**Los Angeles Unified School District
Office of the Inspector General**

Technical Evaluation

**Pinner Construction Co., Inc.
and the Taft Charter High
School Plumbing Utilities
Project**

**24-440-TE
May 19, 2025**

Figure 5. Change Order T-518 – Justification Excerpt (August 24, 2021)

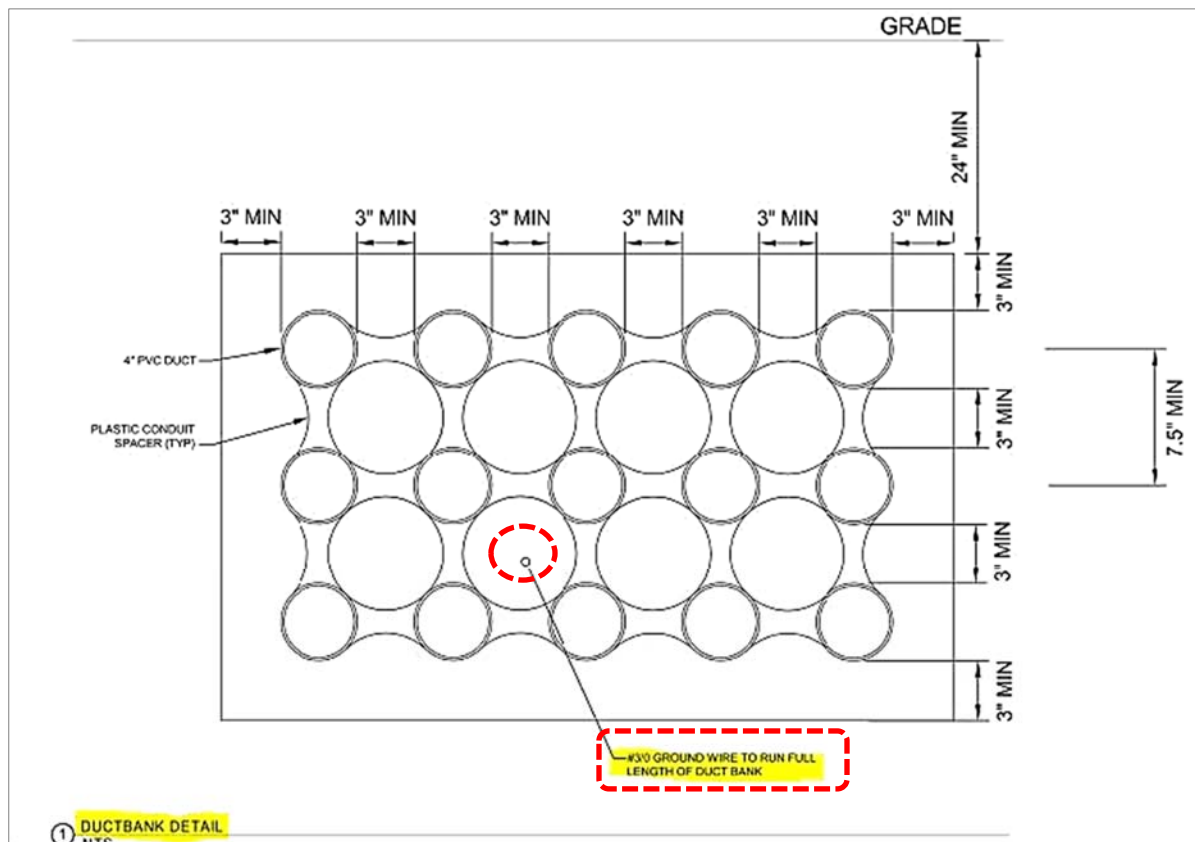
- a) Change Order T-518 – Ground Wire in Electrical Duct Banks – 8/24/2021
Cost Amount: \$35,047.

This change order stated that an electrical drawing sheet, referring to a typical duct bank detail (1/1A-E8.00) with ground wire, applied only to electrical banks connecting to a future switchboard at the electrical yard. It also stated that this note was not indicated in electrical duct banks on other electrical drawings (Figure 5). However, the electrical site plan describing the overall scope of work for the whole project provided a note stating the general requirements for the underground conduits, which showed a typical ground wire duct bank detail per LAUSD requirements (Figures 6 and 7). A ground wire is typically required in a duct bank by electrical codes, which require the grounding of electrical systems to ensure safety.

1. We recommend that Pinner credit the LAUSD appropriately for Change Order T-518.

Pinner responded that they do not intend to issue a credit to the LAUSD for Change Order T-518, because it was approved by FSD PEX.

FSD PEX did not agree that the contract drawings included the ground wires for all duct banks. They said the note referenced on sheet 1A-E4.01 is called out for the duct bank from the temporary MSA to the 4000A switchboard at the electrical yard. This detail is not referenced at any other duct bank on the drawings, nor is it called to be typical. The change order given to the contractor was exclusively for the remainder of the duct banks that were not referenced.

Figure 7a. Electrical Site Plan– Package 1A Sheet 1A-E1.01

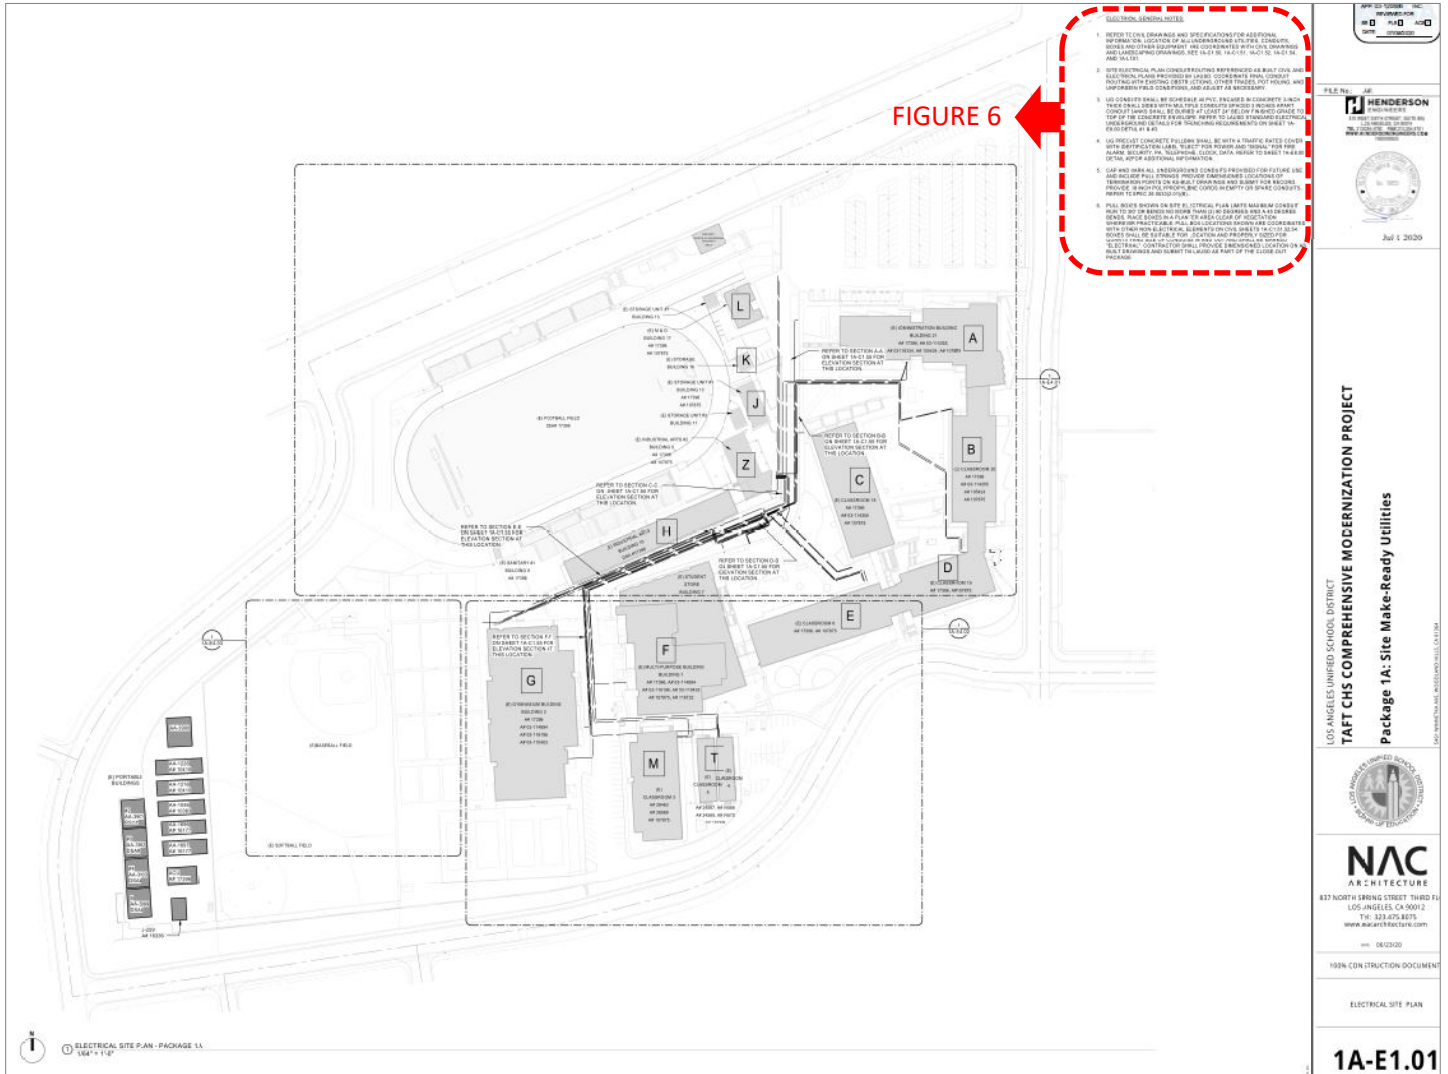
As noted above in Figure 6, the electrical plan described the overall requirements for the work under the electrical general notes (Figure 7a). The overall electrical single line diagrams also included the same electrical general notes, which instructed the Contractor to refer to the LAUSD Standard Electrical Underground Details for trenching requirements on sheet 1A-E8.00 details No. 1 and No.3 (Figure 7b).

Figure 7b. Electrical One-Line Diagram– Package 1A Sheet 1A-E6.01 Excerpt

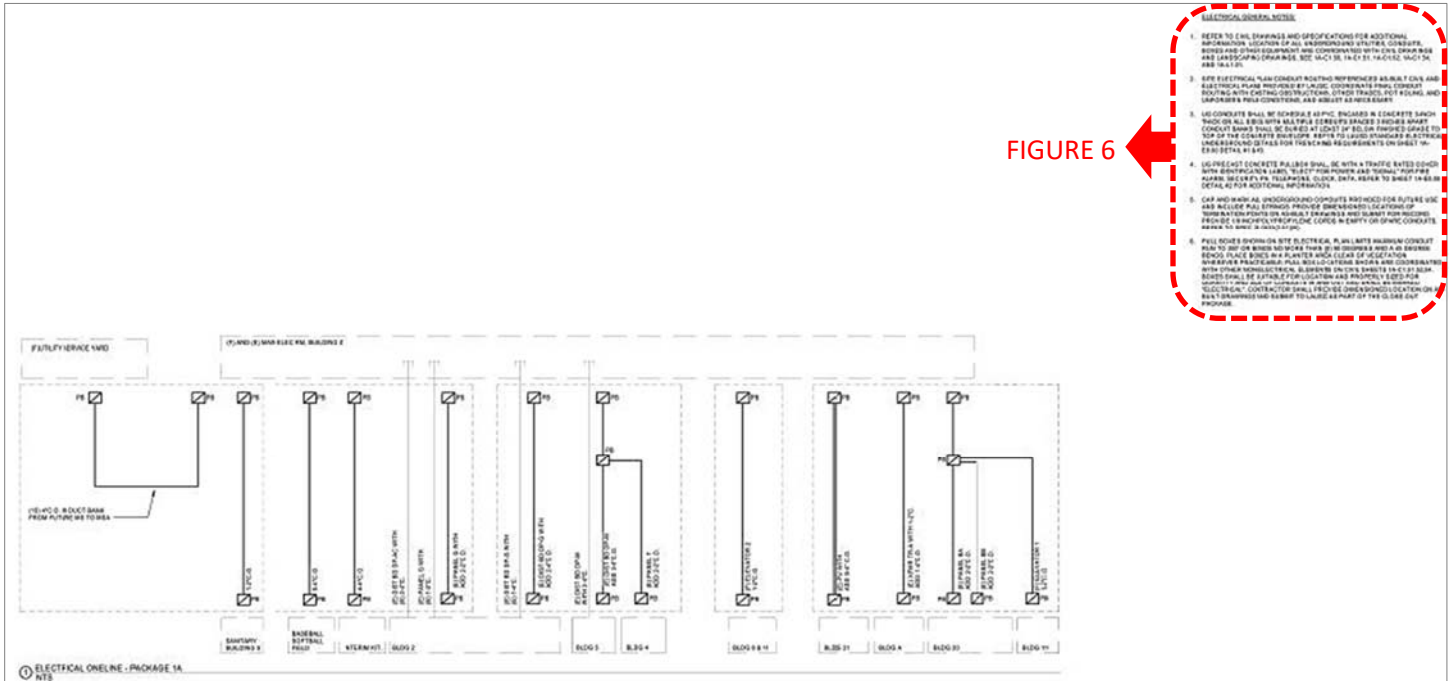
Since contract document plan sheets 1A-E1.01 and 1A-E6.01 provided a general note directing to another detail sheet for trenching requirements for the overall work, which included the ground wire, it implied that the ground wire was part of the overall duct bank installation. Since the general notes specified a standard for the installation in the overall site plan, it is reasonable to interpret that standard as applying uniformly across the project and to all relevant duct banks unless explicitly stated otherwise. If the detail sheet showed the ground wire for the duct banks, it indicated that the ground wire was required for the duct banks as a whole.

**Figure 7c. RFC No. 41.1 Documentation -Enlarged Partial Area
Package 1A Sheet 1A-E4.01 Excerpt**

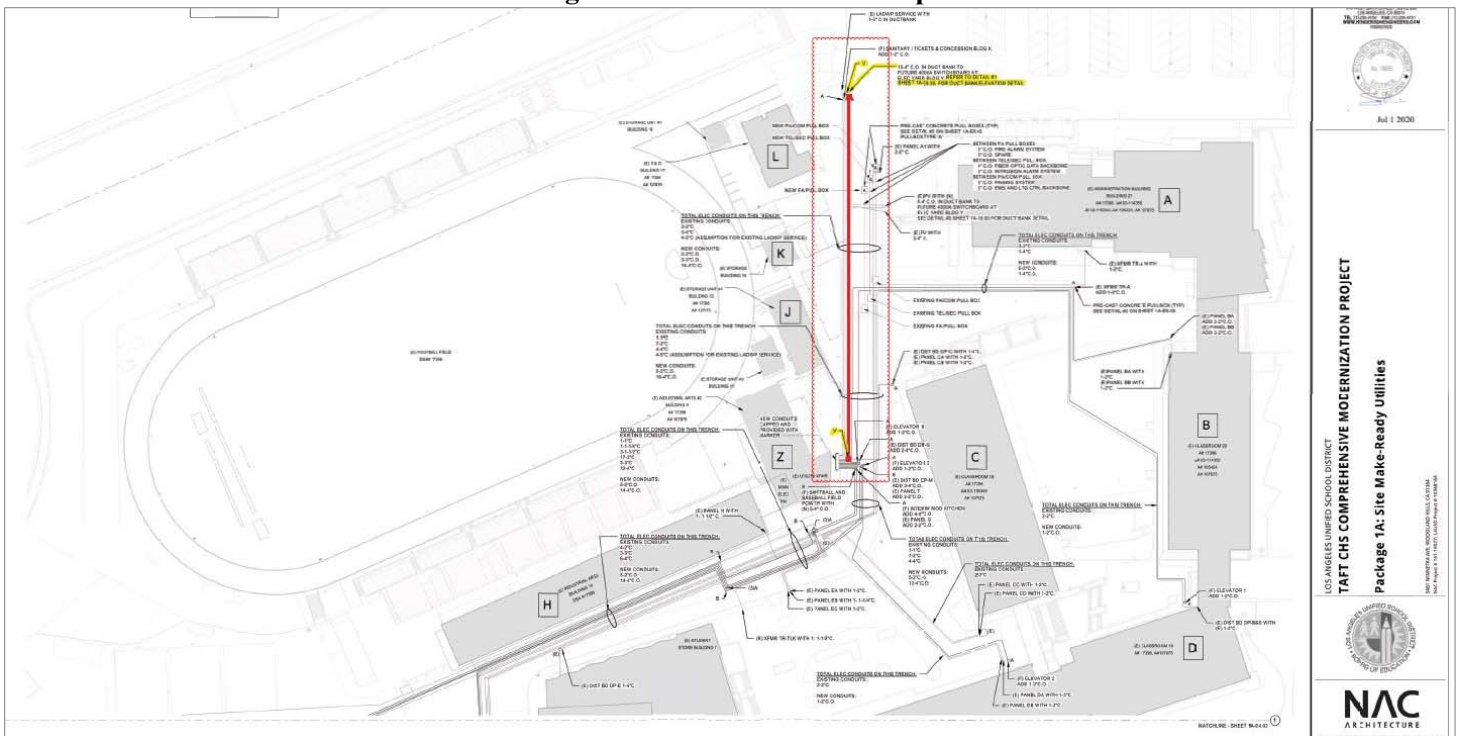
Although the notes on sheet 1A-E4.01 (Figure 7c) referred to detail sheet 1A-E8.00 for a portion of the duct banks connecting to the future switchboard, they did not necessarily exclude the requirement for the rest of the duct banks.

Figure 9. CCD 009 Trench Detail – November 18, 2022

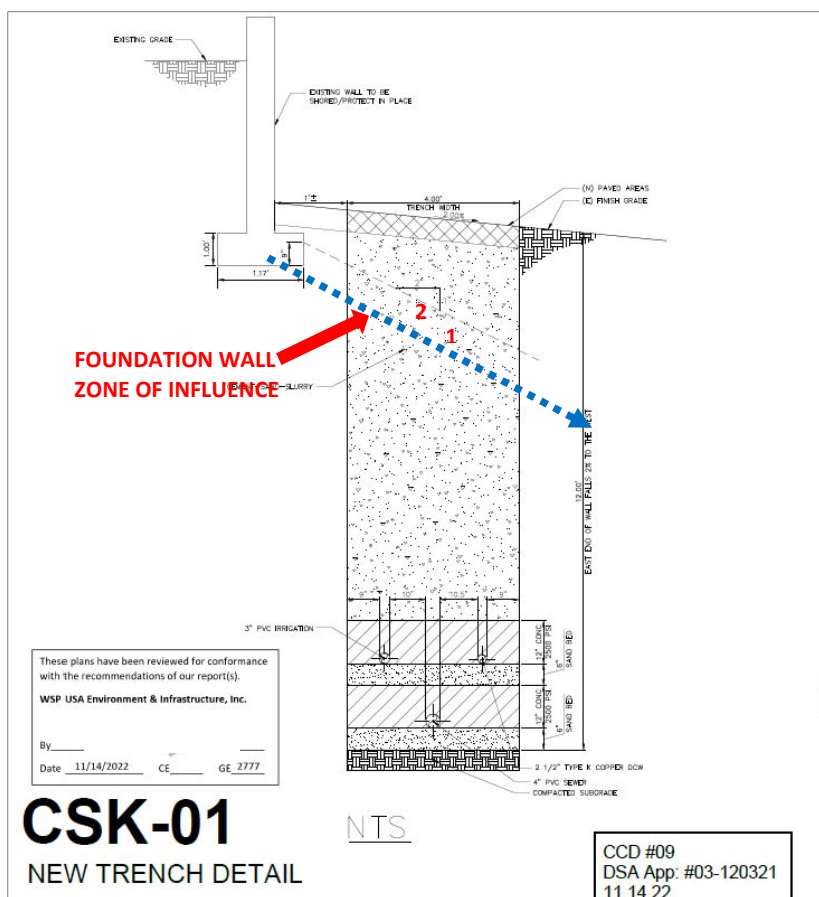
There were three change orders for improper excavation procedures under one of the exterior wall footings of Building M, as noted below per Construction Change Document (CCD) 009 (Figures 8 and 9). These change orders added a cost of \$186,930:

It was the Contractor's responsibility to coordinate the work and ensure the structural integrity of the adjacent buildings. The resolution of this issue was affected by design deficiencies in the design and construction documentation, which did not account for adjacent building site conditions.

1. We recommend that Pinner review the inadequate excavation procedures and implement changes to prevent similar issues in the future. These might include additional training, better planning and coordination, and stringent oversight.
2. We recommend that the FSD AM branch improve the coordination of the work of the commissioned architecture and engineering teams on underground utilities in relation to their immediate project site context. Further recommendations on the management of these issues are provided under Findings Nos. 4 and 5 below.
3. We recommend that the FSD PEX branch review the process that delayed the approval of CD 162 to simplify, improve, and speed up the approval process of directives that impact the project's schedule and cost.

Pinner understood the concern expressed by the OIG regarding CCD 009. They indicated they will continue to enhance their coordination and management plan (pre-task planning, planning review, and stringent installation oversight) to minimize similar issues on future projects.

Figure 15. Potholing Site Plan – Pacific Coast Locators Inc. Excerpt – April 18, 2020

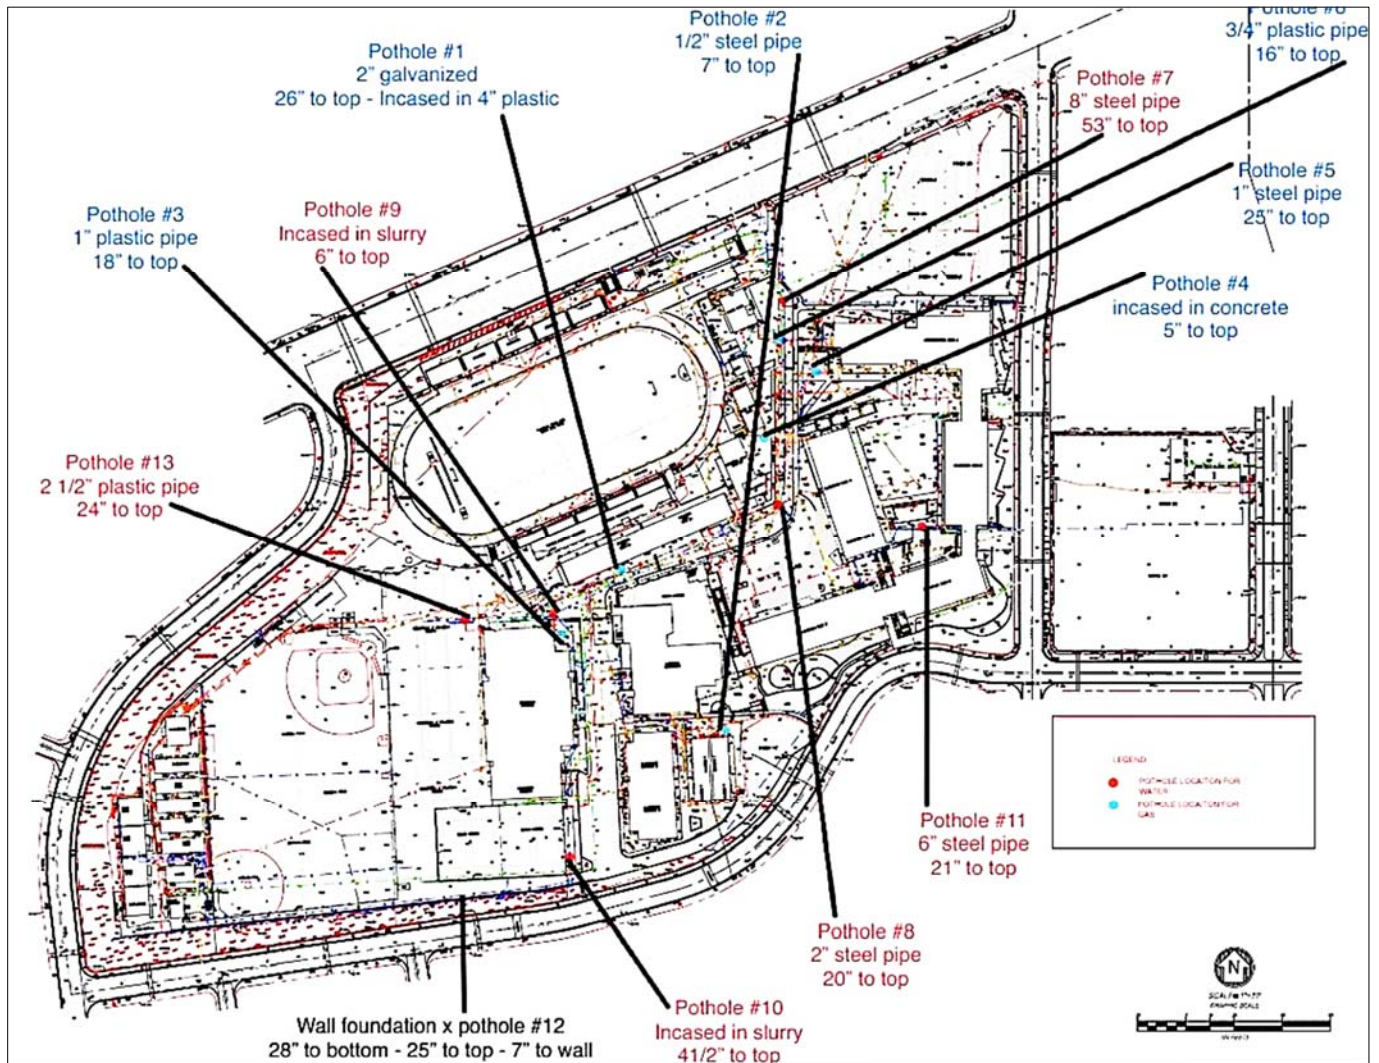
investigation effort (Figure 15). However, the land survey did not fully identify most of the utilities needed for planning and coordination, and the potholing was not thoroughly completed (Figure 16). In our interviews with the commissioned architecture and engineering teams, we determined that the number of pothole areas was insufficient and that the locations could have been better selected.

Figure 17. Change Order T-527 – RFC No. 49 Justification Excerpt – June 1, 2021

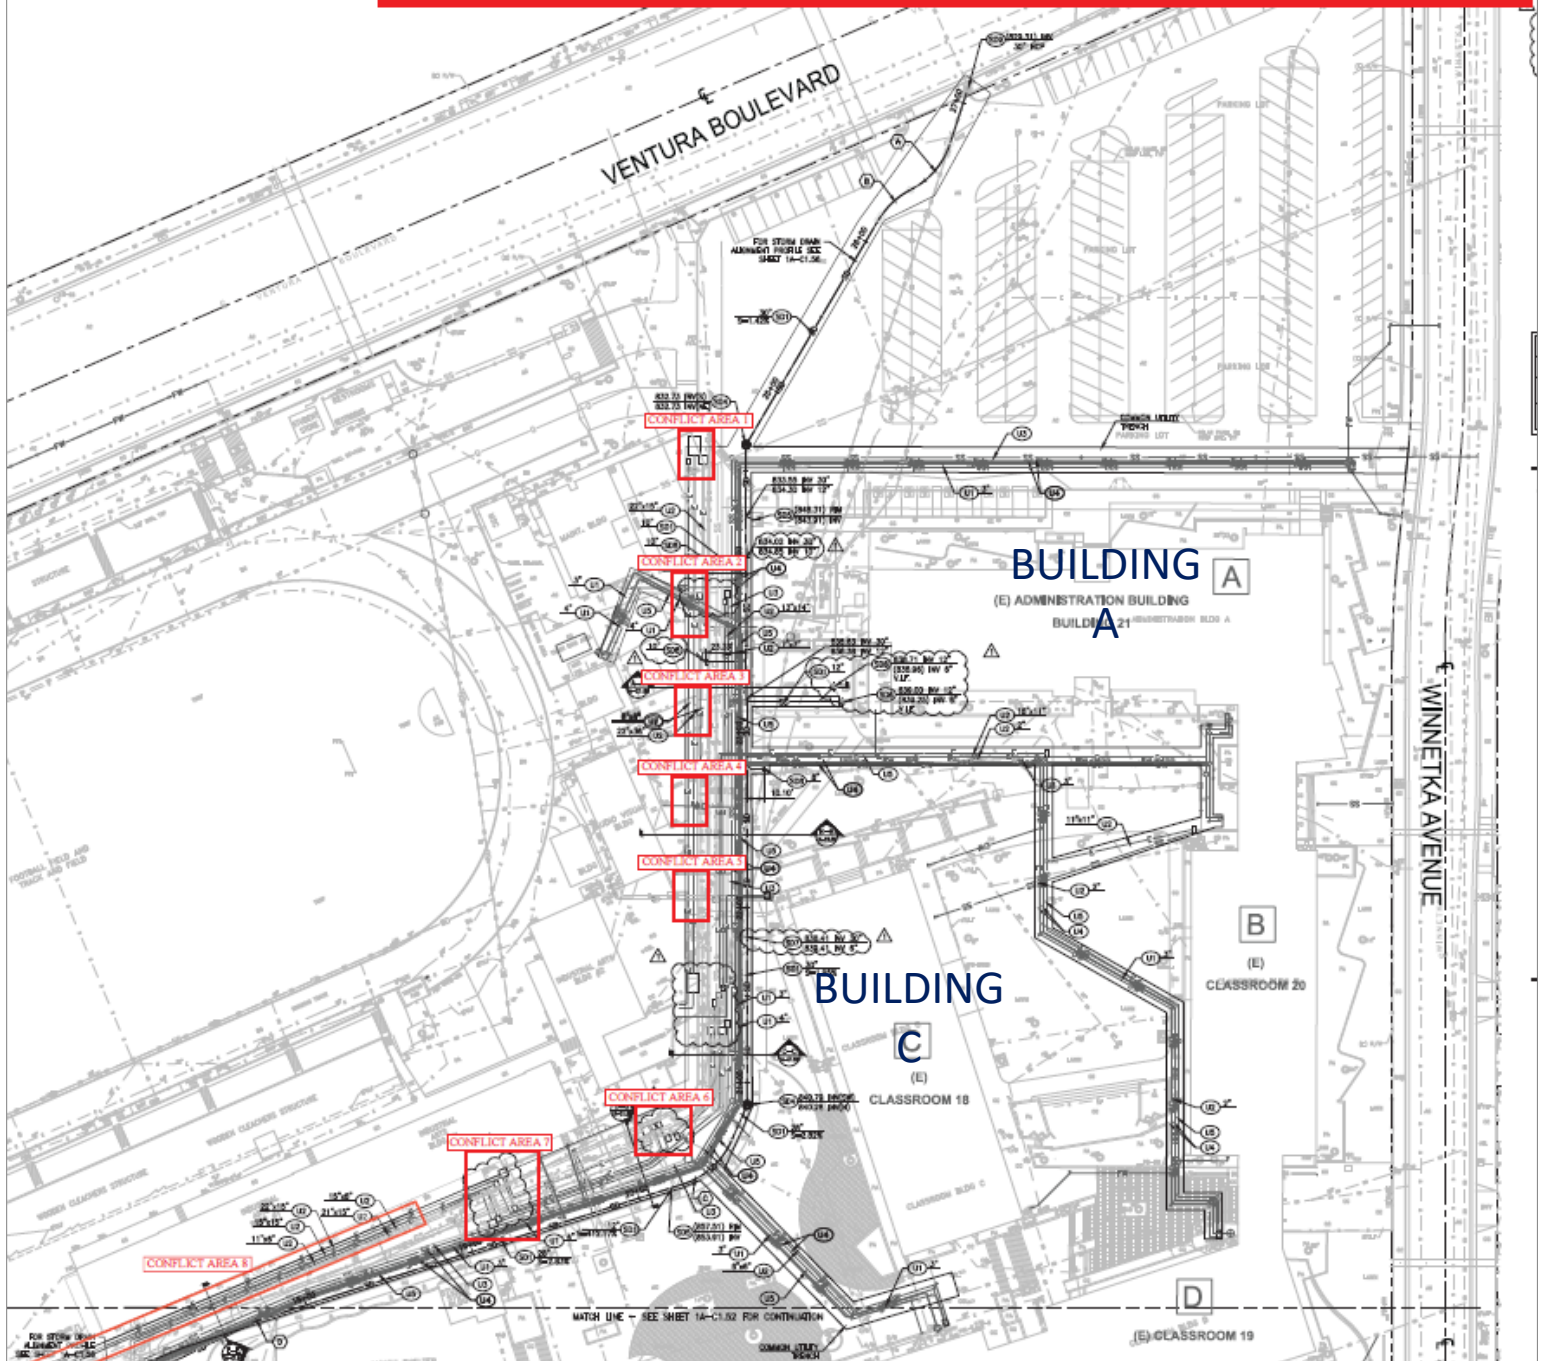
Change Order T-527 explained many of the design conflicts in the project, which resulted in several change orders that increased the project's cost. (Figure 17). Adequate site investigation on the location of utilities during the planning and design phase of the project could have mitigated the impact of change orders for unforeseen conditions.
